Technical Report: Appendices A-G Phase I Cultural Resources Investigations and Phase II National Register Site Evaluations

Bell Bend Nuclear Power Plant
Luzerne County, Pennsylvania
ER 81-0658-079

Prepared for:
UniStar Nuclear Energy, LLC

October 11, 2010

*Example for
Bridge Measuring*

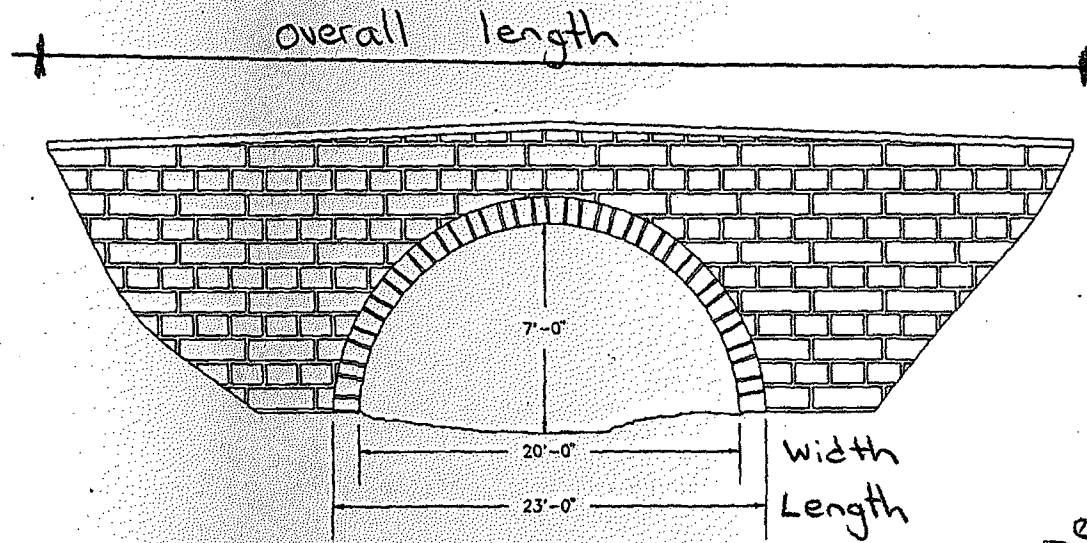
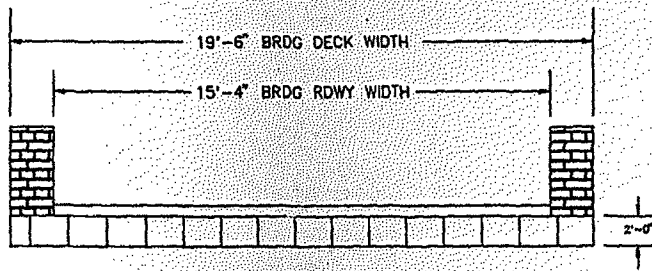
15. Stone Arch Bridge/North Market Street Bridge, Salem Township, Luzerne County: Please supply the correct length measurement of this bridge (see attached guidance for measuring bridges). The submission states that there are only 3 intact stone arch bridges in the county. Our on-line Geographical Information Submission shows that there are over 50 stone arch bridges. Please evaluate this bridge in the context of the bridge survey.
16. Wapwallopen Historic District (potential), Conyngham Township, Luzerne County: Please contact our agency to schedule a site visit to verify the presence and boundaries of a historic district.
